Access Compliance Report

Public Rights-of-Way

(Pedestrian Signals)

Intersection ID: N/A	Main Street:	Cross Street: N/A	Location: N/A
ADA ID: 31B3F3CDBA35	Signal Type: Two Push Buttons-Non APS	Overall Compliance: No	Severity Score: BTN 1:N/A BTN 2: N/A No BTN: N/A
Codes/Mitigation Info/Possible Solution		Field Measurements/Component Compliance

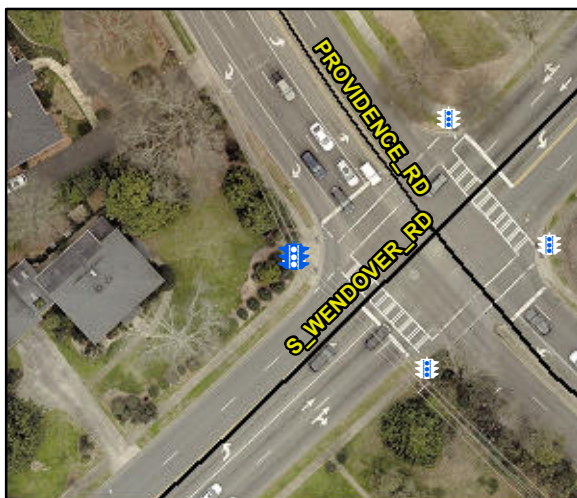
Compliance	Description	Data	Compliance	Description	Data
	Button Count	Button2	N/A	Distant to Additional Button (in)	N/A
	Additional Button Present?	No		Additional Button ID	N/A
N/A	Signal Buttons Required?	N/A	N/A	Additional Ped Posts Required	N/A
	How Many Ped Street Xings?	2		Located In An Island/Median?	No
N/A	B 1 Sign Present?	Yes	N/A	B 2 Sign Present?	Yes
Yes	B 1 Sign Purpose?	Yes	Yes	B 2 Sign Purpose?	Yes
Yes	B 1 Sign Lettering & Contrast?	Yes	Yes	B 2 Sign Lettering & Contrast?	Yes
Yes	B 1 Parallel To XWalk?	Yes	Yes	B 2 Parallel To XWalk?	Yes
Yes	B 1 PAR to Button?	Yes	Yes	B 2 PAR to Button?	Yes
Yes	B 1 PAR to XWalk?	Yes	Yes	B 2 PAR to XWalk?	Yes
Yes	B 1 Clear Floor Space?	Yes	Yes	B 2 Clear Floor Space?	Yes
N/A	B 1 FWD Approach?	Yes	N/A	B 2 FWD Approach?	Yes
N/A	B 1 FWD Approach Constrained?	No	N/A	B 2 FWD Approach Constrained?	No
No	B 1 FWD Approach Reach (in)	14.0	No	B 2 FWD Approach Reach (in)	14.1

N/A	B 1 FWD Approach Width (in)	N/A	N/A	B 2 FWD Approach Width (in)	N/A
N/A	B 1 FWD Approach Obstruction?	Yes	N/A	B 2 FWD Approach Obstruction?	Yes
N/A	B 1 FWD Approach Obstruction Dist (in)	14.0	N/A	B 2 FWD Approach ObstructionDist (in)	14.0
N/A	B 1 PARA Approach?	Yes	N/A	B 2 PARA Approach?	Yes
N/A	B 1 PARA Approach Constrained?	No	N/A	B 2 PARA Approach Constrained?	No
No	B 1 PARA Approach Reach (in)	11.0	No	B 2 PARA Approach Reach (in)	11.0
N/A	B 1 PARA Approach Width (in)	N/A	N/A	B 2 PARA Approach Width (in)	N/A
N/A	B 1 PARA Approach Obstruction?	Yes	N/A	B 2 PARA Approach Obstruction?	Yes
N/A	B 1 PARA Approach Obstruction Dist (in)	11.0	N/A	B 2 PARA Approach ObstructionDist (in)	11.0
No	B 1 Clear Floor Space Slope (%)	6.0	Yes	B 2 Clear Floor Space Slope (%)	1.8
Yes	B 1 Clear Floor Space XSlope (%)	1.8	Yes	B 2 Clear Floor Space XSlope (%)	1.9
N/A	B 1 PAR Slope (%)	3.9	N/A	B 2 PAR Slope (%)	1.7
Yes	B 1 Height (in)	41.5	Yes	B 2 Height (in)	37.2

Yes	B 1 Clear Xing Direction?	ClearlyMarked	Yes	B 2 Clear Xing Direction?	ClearlyMarked
	B 1 Crossing Direction	To SE		B 2 Crossing Direction	To NE
No	B 1 DistanceTo XWalk (in)	146.0	No	B 2 DistanceTo XWalk (in)	94.0
No	B 1 DistanceTo Curb (in)	129.0	No	B 2 DistanceTo Curb (in)	129.0
Yes	B 1 Diameter (in)	2.0	Yes	B 2 Diameter (in)	2.0

Possible Solutions: Replace Signal Push Button With APS Button on New Post. Remove & Relocate Sign.
